CITY OF DAHLONEGA

HISTORIC PRESERVATION COMMISSION

ZOOM MEETING AGENDA

MONDAY, JUNE 22, 2020 AT 6:00 PM

DIAGRAM # 1

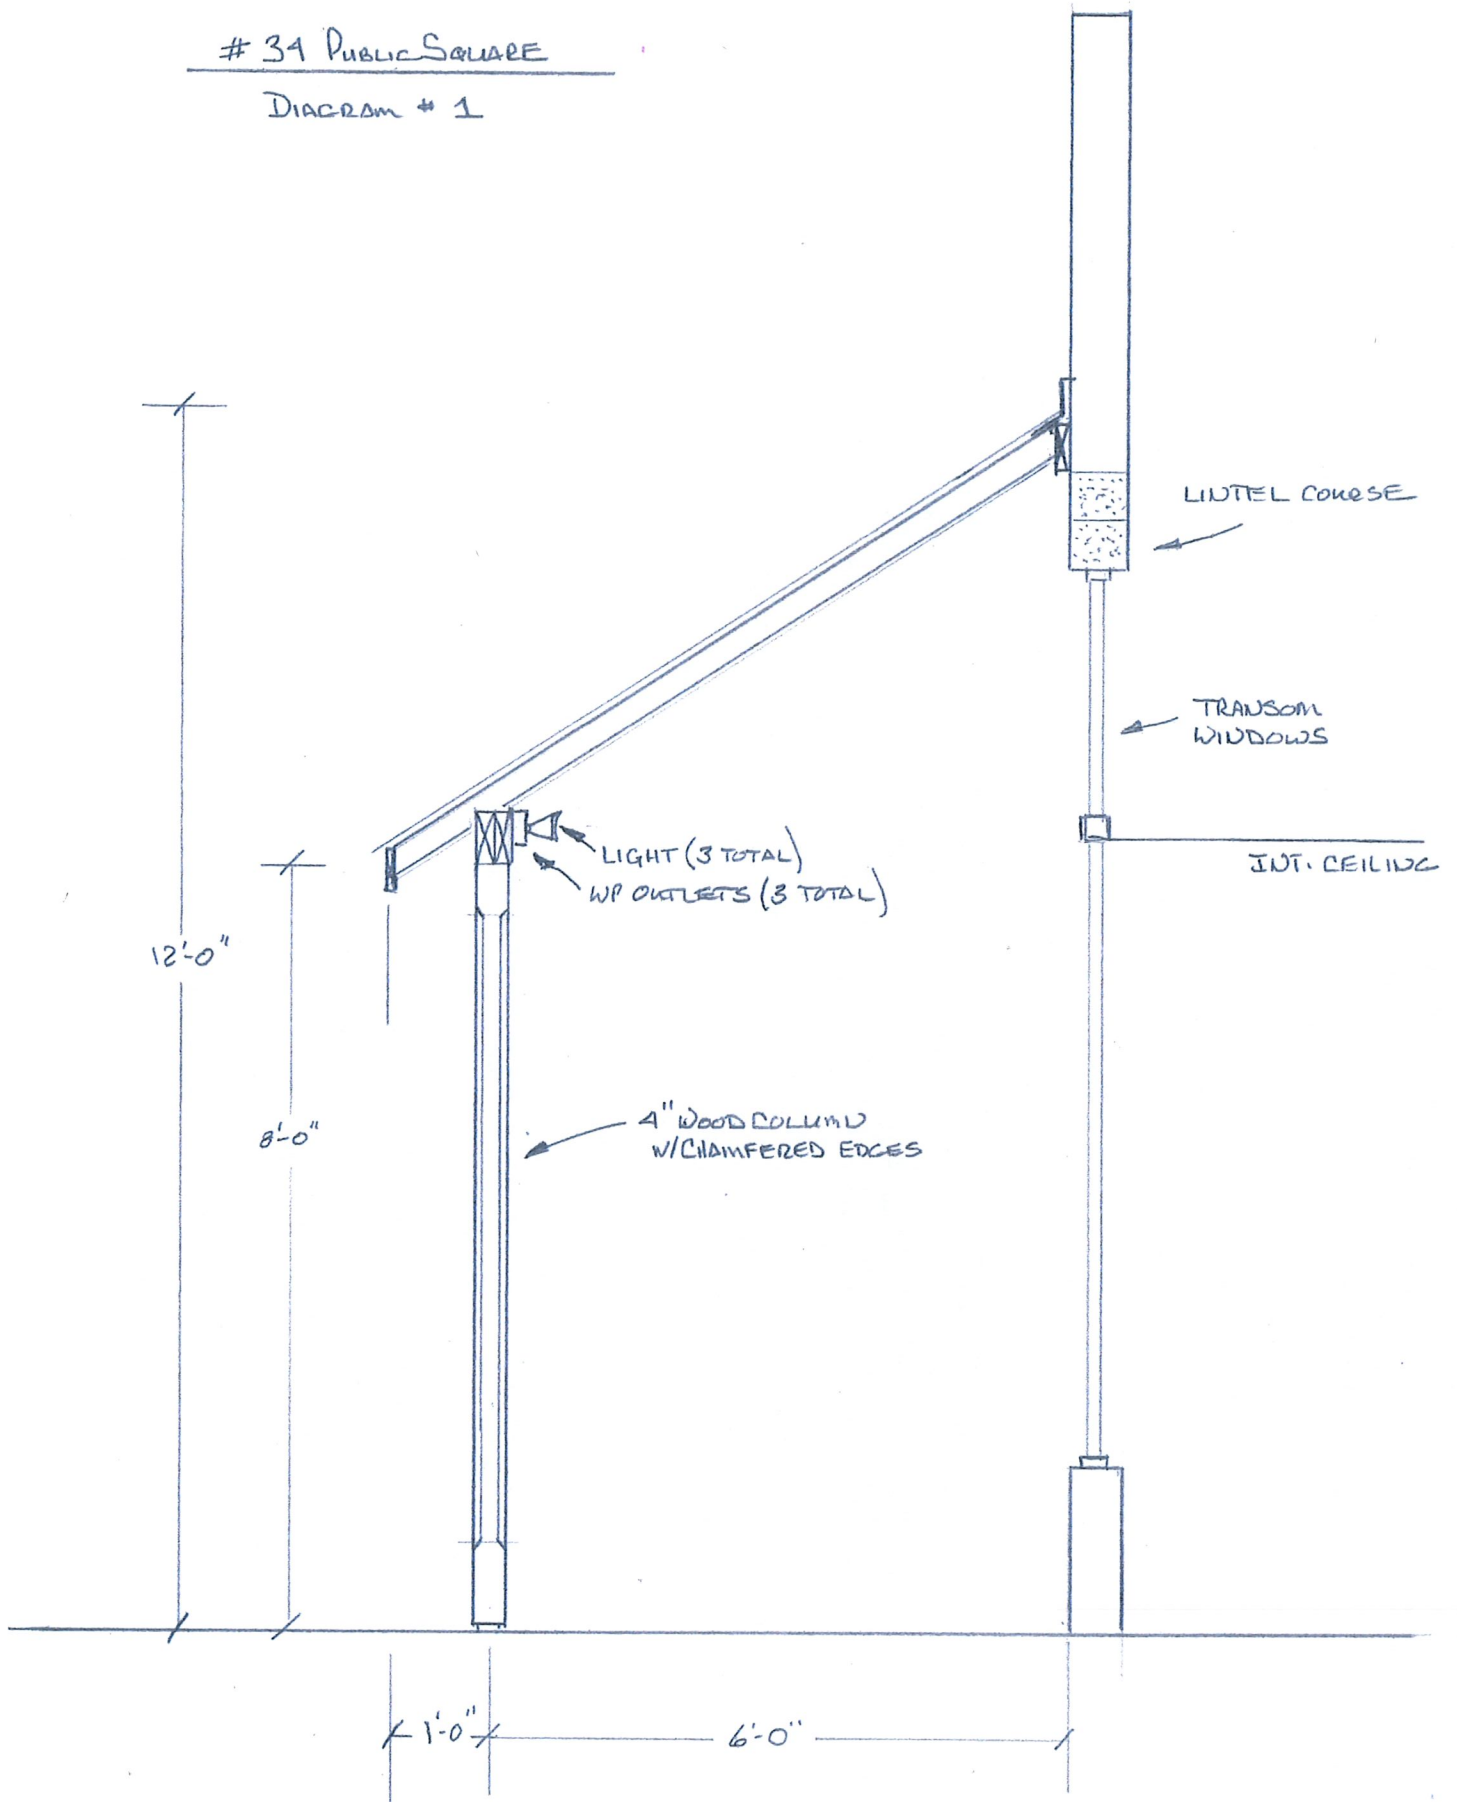
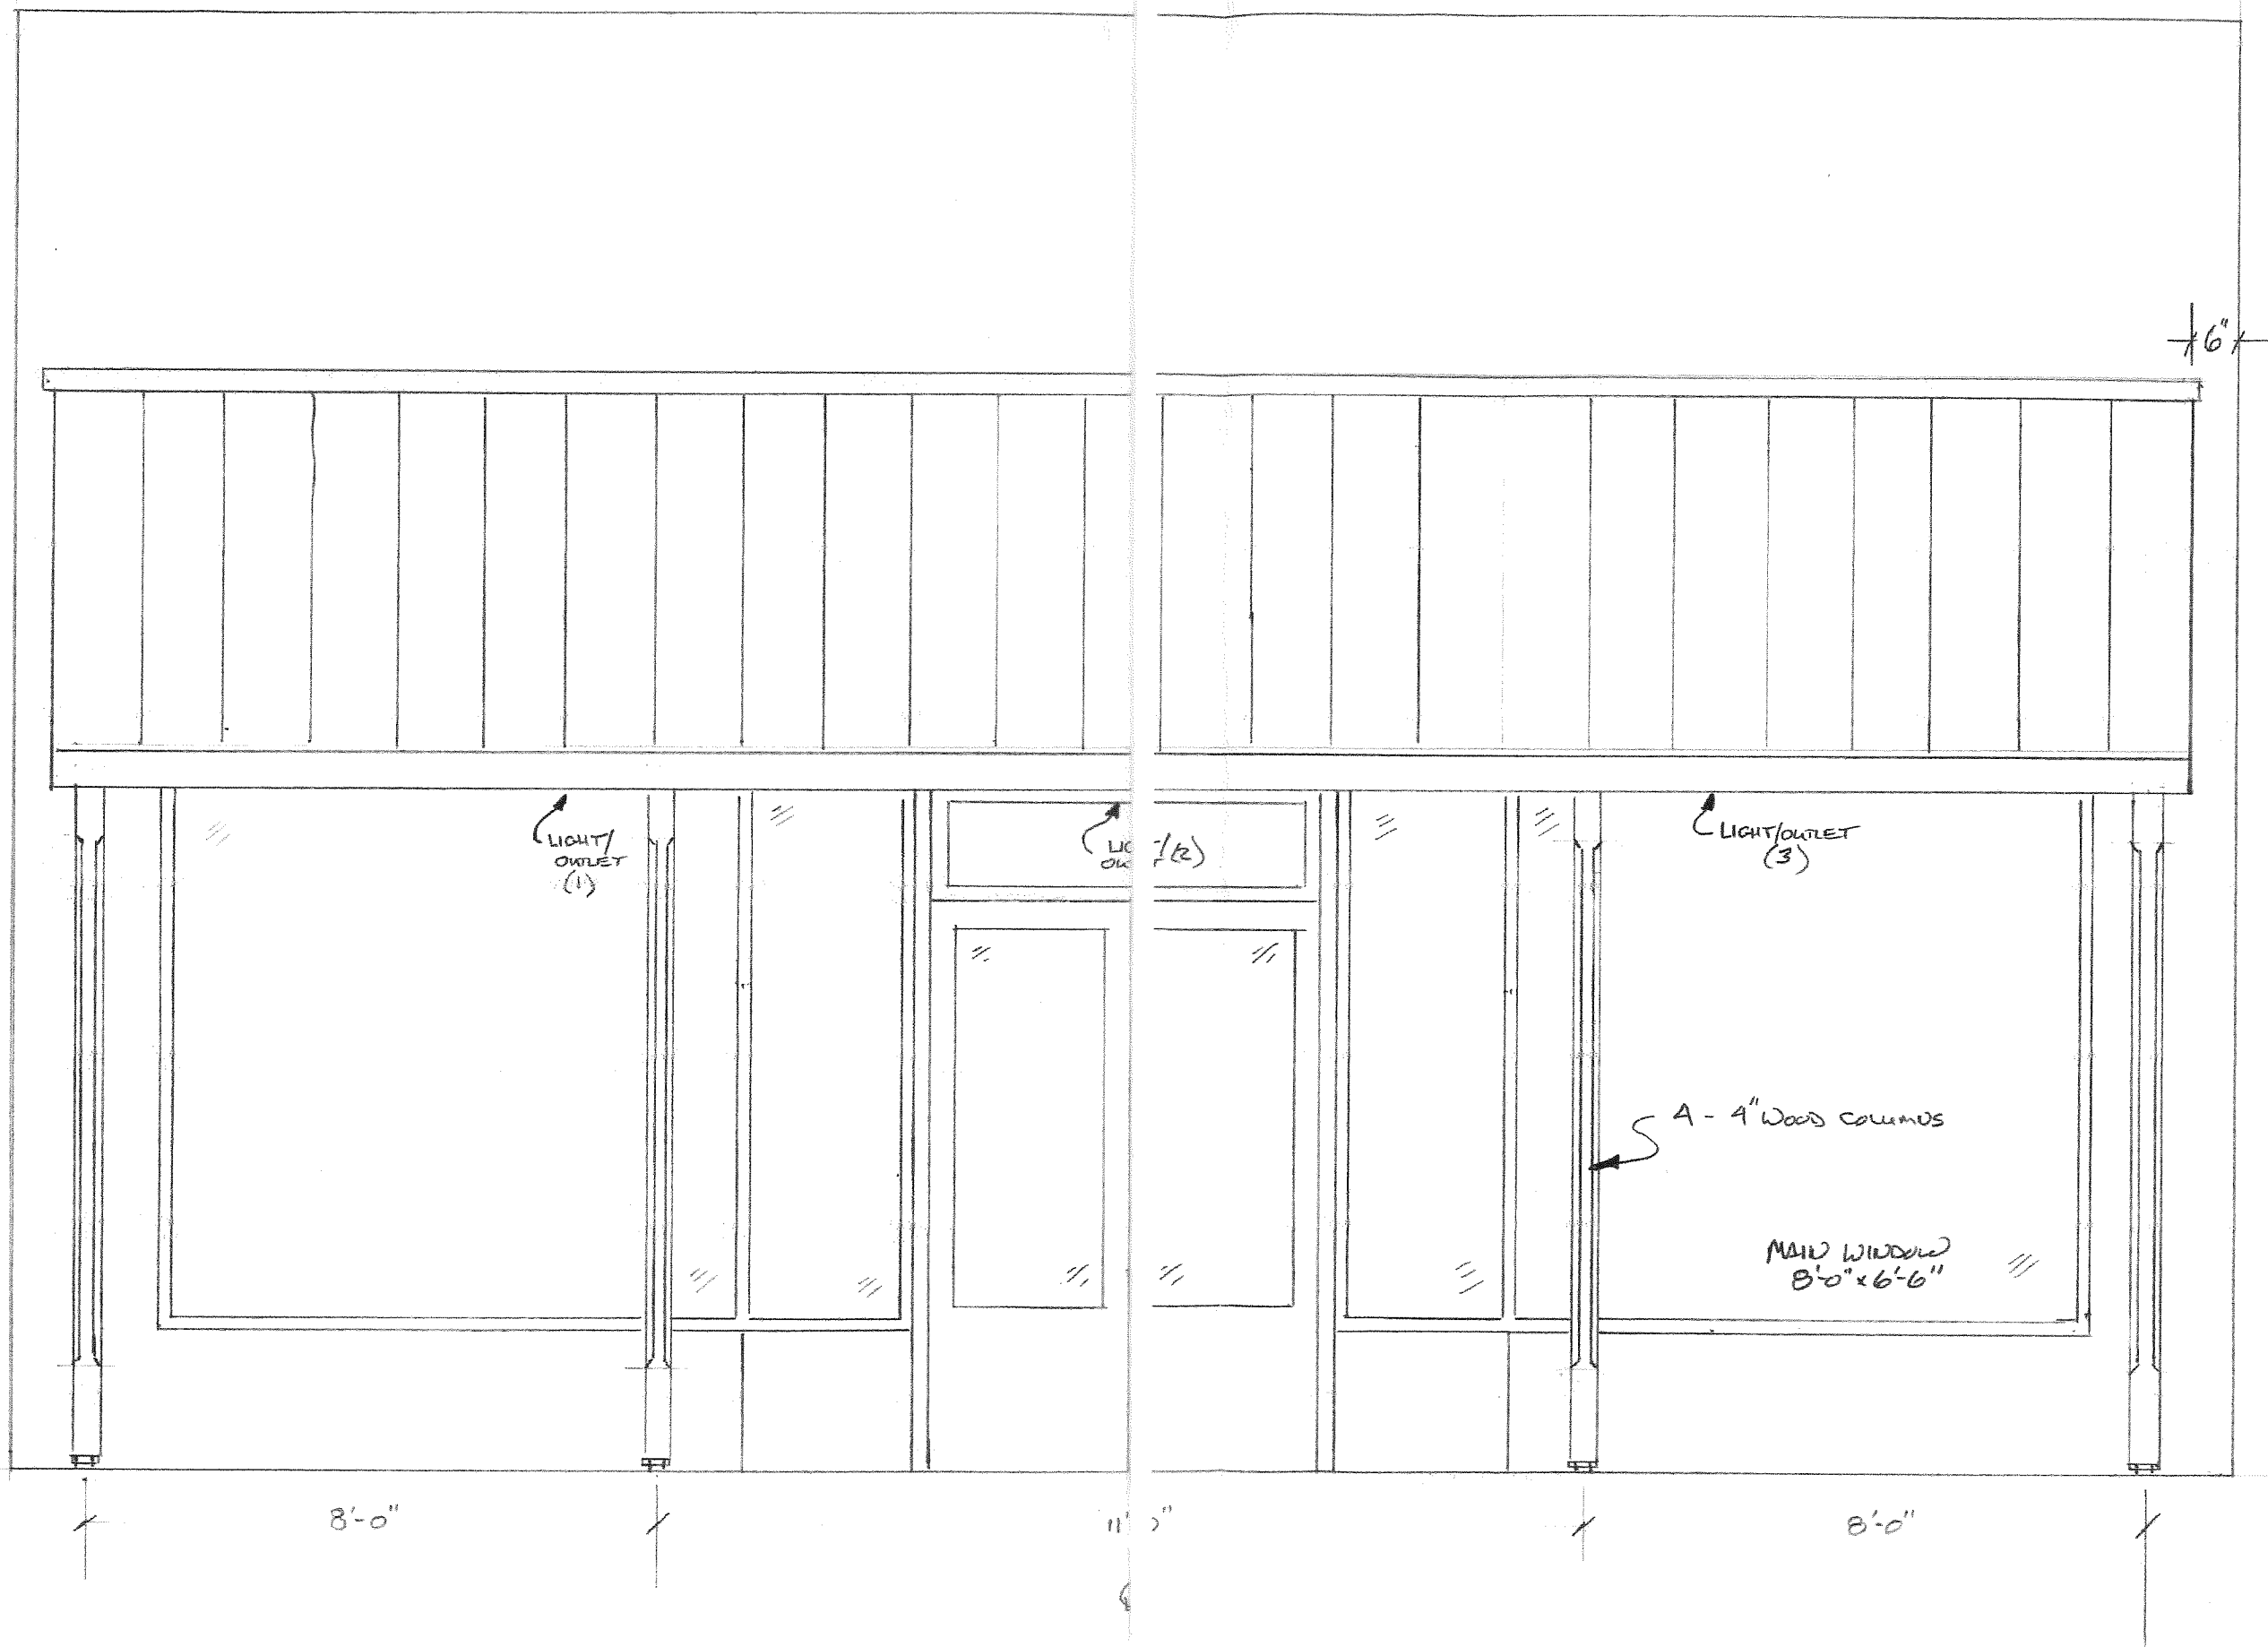
- *Exterior Lighting* (3.6) – The proposed project involves installing electrical power for exterior outlets and new light fixtures that are to be integrated into the new canopy. **The proposed lighting includes three exterior dual-bulb fixtures to be attached on the inside of the canopy’s outer header. The fixtures will include flood lights (with 40 Watt-equivalent bulbs) pointed toward the building’s front façade, one for each storefront and one for the centered entry. The electrical wiring will be housed in conduit attached to the canopy’s rafters and painted to match.** When determining the appropriateness of lighting, consider the following DDGs:

- 3.6.5 Lighting may be used to illuminate entrances and/or signs or to highlight ornamentation. Ornamentation should not be obscured by mounted fixture.

Historic Images of the Whitmire Building:

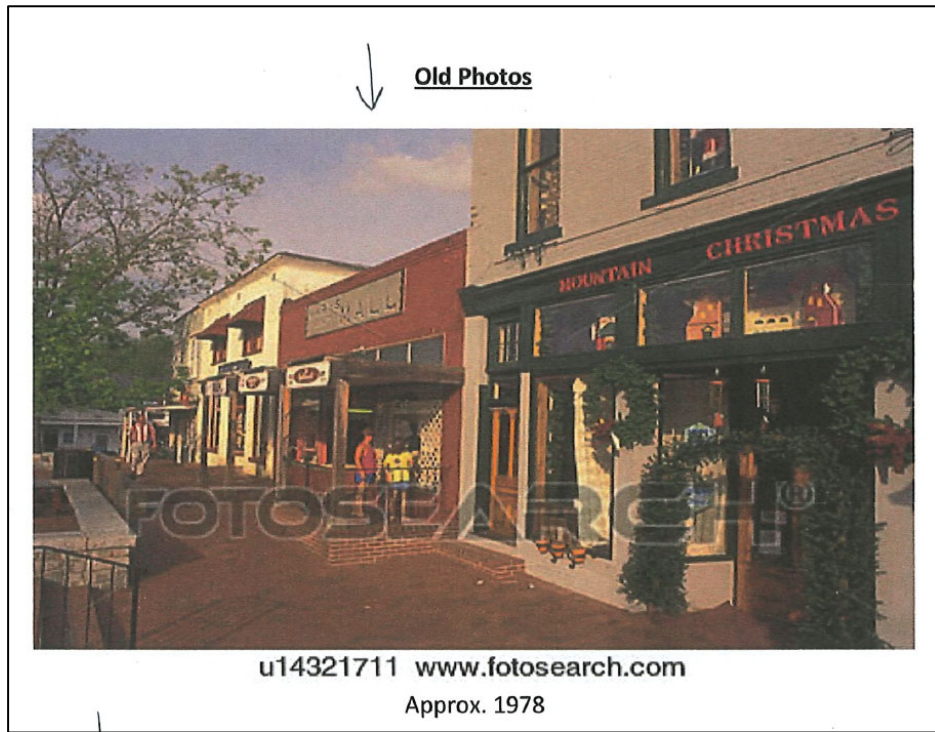
- o **Figure 1:** The photograph dated “Approx. 1978” on page 5 of the “Proposed Repairs” document (attached to a previous application for COA, submitted to HPC in February 2020) is likely misdated. In the photo, the streetscape is of brick and there is a retaining wall adjacent to the building, indicating that the photo was taken since the renovation of downtown Dahlonega’s streetscape, which occurred in the mid-2010s. **The frame structure with flat roof in that mid-2010s image may have been replaced or may be the same structure as exists today—now with trim on the cornice, decorative brackets, wrapped posts, and paint.**

- o **Figure 2:** A photograph taken in 1982, during the development of Dahlonega’s Nation Register nomination, shows an entirely different canopy attached to the Whitmire Building’s front façade. In that image, the **canopy is entirely metal with a flat roof supported by thin aluminum-tube posts.**

- o **Figure 3:** The 1958 photograph shows the Whitmire Building with **no attached canopy.**
- **The analysis of the photos suggests that the existing canopy is not a historic feature; however, its removal and replacement with a canopy with a different roof form will constitute an alteration in the appearance of the Whitmire Building and the historic district, requiring a COA.**

FRONT ELEVATION SCALE: 1/4" = 1'-0"
PARK STREET.

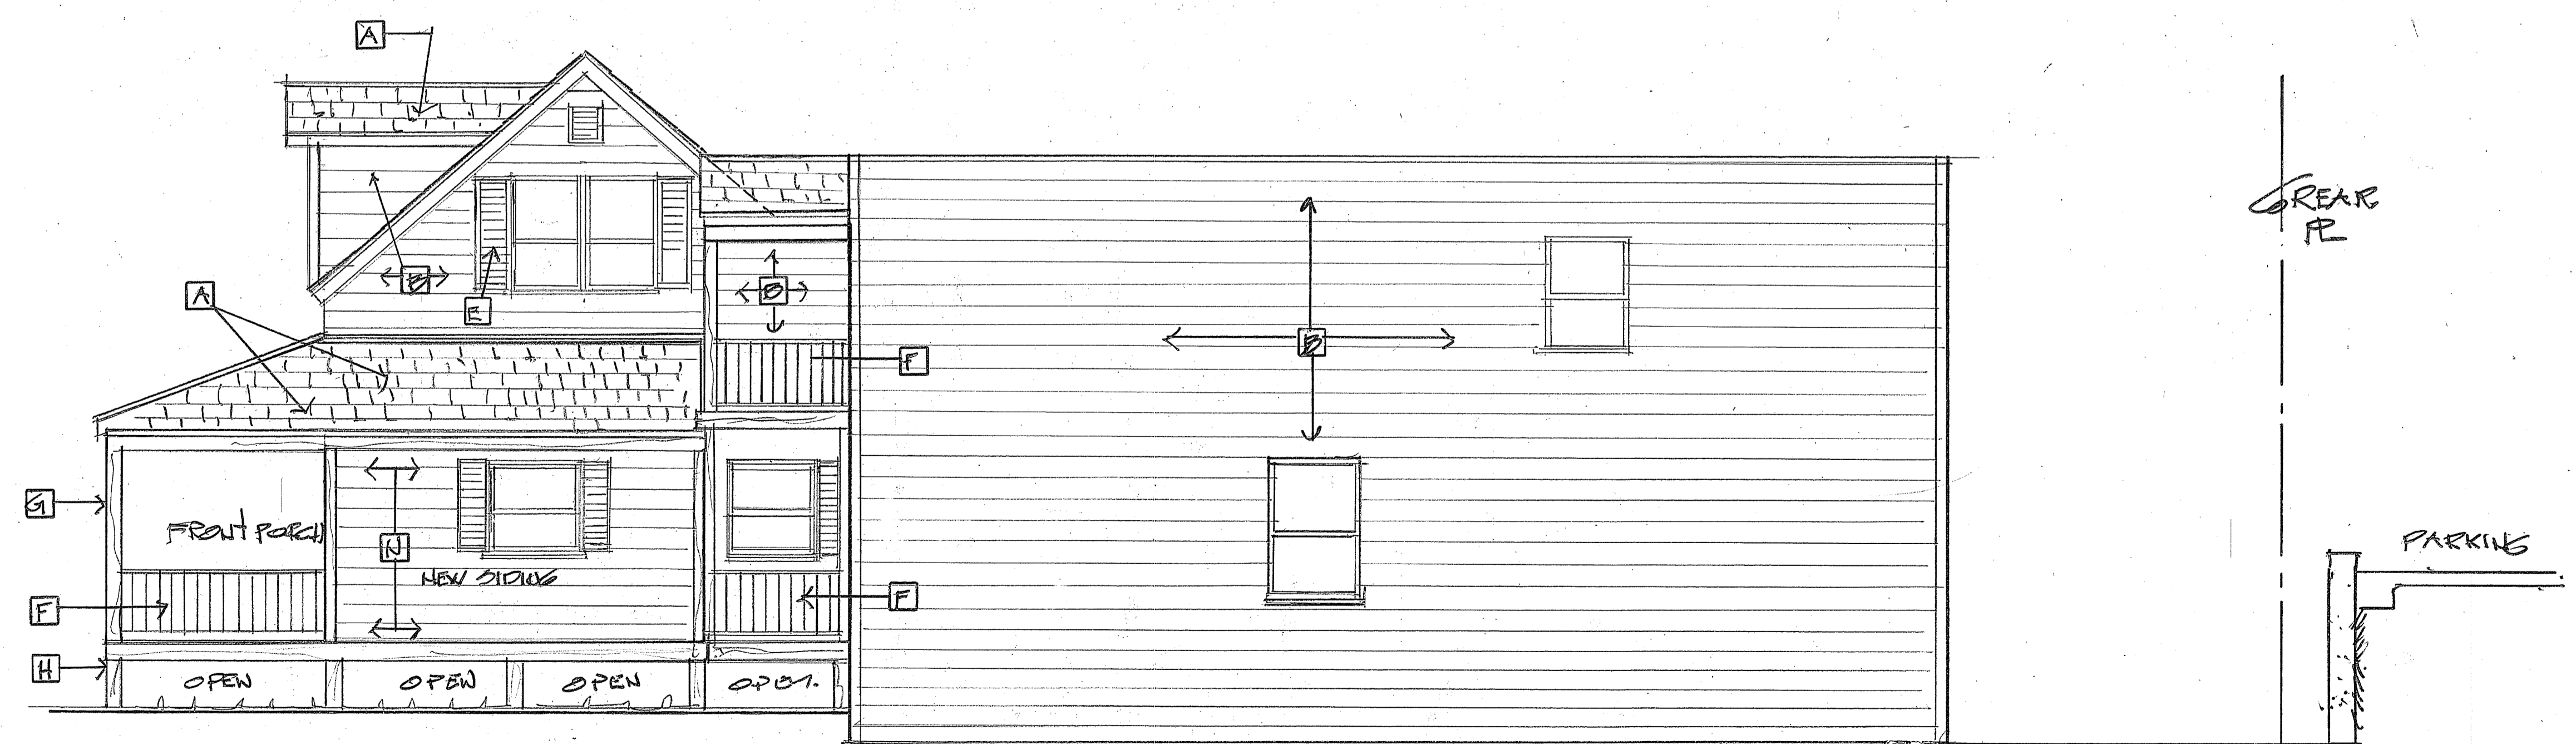
- *Roofs* (4.5) – All existing roofs are to remain in place and no additional roofs are to be added.
- *Exterior Walls and Trim* (4.6) – On page 69, the DDGs state that “the form, materials, and details of exterior walls can contribute to a building’s historic character. Bays and siding materials contribute to the diversity of wall forms in the district. Pattern, scale, texture, color, and the detail of historic wall materials characterize buildings in the historic district.” **The proposed siding material and profile (hardy plank clapboard) match that of the existing building. Enclosing the porch will, however, alter the symmetry of the 3-bay front façade.**

The size and scale of the proposed enclosure will not overwhelm the existing building or site; however, as proposed, the enclosure will not be differentiated from the original building. By continuing the plane of the front façade to a new corner, it may no longer be possible to identify the historic portion of the building.

Preservation Brief #14, which is adopted as code in DDG 5.2.2 (quoted above), explains that “a new addition to a historic building should protect those visual qualities that make the building [significant].”¹ It is recommended that the HPC and applicant consider ways in which the proposed addition can be differentiated from the primary façade. This may be done by simply setting the front (west) façade of the addition back a few inches from the existing front plane.
